## Baroque Churches (Philippines) No 677bis

Baroque Churches of the Philippines

### 2 Issues raised

Church of Immaculate Conception of San Agustín, Manila - Map showing the proposed buffer zone

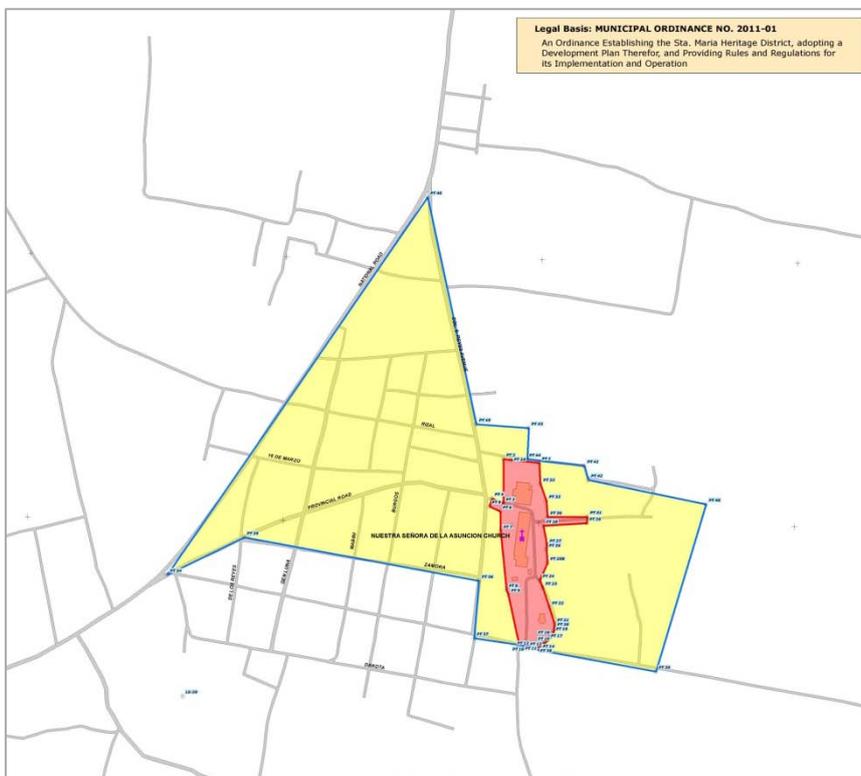
The boundaries of the Church of the Immaculate Conception of San Agustin remain at 2.43 hectares, which corresponds to the property boundaries inscribed in 1993. The newly established buffer zone of 106.13 hectares covers the entire surrounding fortified section of the historic Intramuros. It provides excellent protection to the property components both from potential physical and also visual impacts

ICOMOS recommends that the proposed minor modification to the boundary and buffer zone of the component of the Church of the Immaculate Conception of San Agustin (Manila), Baroque Churches of the Philippines, Philippines, be **approved**.

Church of San Agustín, Paoay - Map showing the revised boundaries of the property and the proposed buffer zone

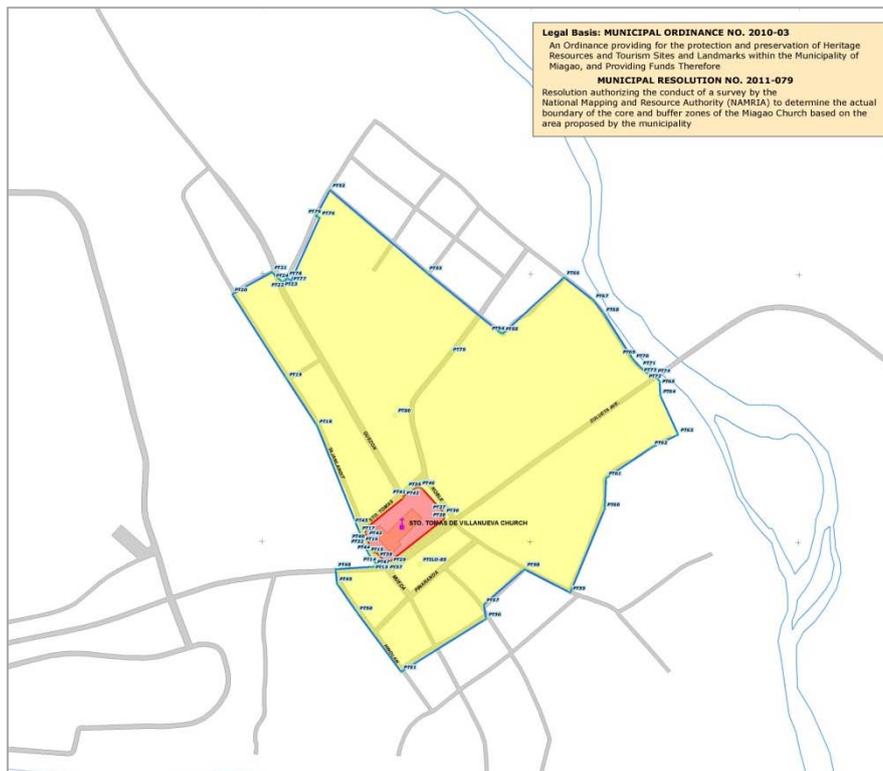
For the Church of San Agustin in Paoay, Ilocos Norte, the proposed property boundaries have been expanded to cover a second – and for the overall series fifth – property component, integrating the Convent Ruins of St. Agustin. While the first site component corresponds to the original boundaries of 2.10 hectares, the additional component adds 0.66 hectare. The extension is justified on the basis that the convent was an integral component of the development of the Church and therefore its ruins need to be included; however the convent was not mentioned in the initial nomination dossier. ICOMOS considers that further information needs to be provided by the State Party as to how the convent contributes to the Outstanding Universal Value of the series. On the basis of a clear rationale for inclusion of the convent, it could also be considered whether an expansion of the existing component would not be a more suitable option than the addition of a fifth component, divided merely by a street from the existing one.

The shared buffer zone surrounding both components covers an area of 13.86 hectares. Its delimitation appears sufficient to provide adequate protection for the existing property of this serial component.

- Justify the specific contribution of the convent ruins to the Outstanding Universal Value of the property;
- Extend the nominated area of the church to include the convent in order to form one single component;
- Expand the buffer zones towards the directions in which the property component is not yet surrounded by a protective buffer zone or to provide justification for the rationale of not establishing buffer zones in these areas.
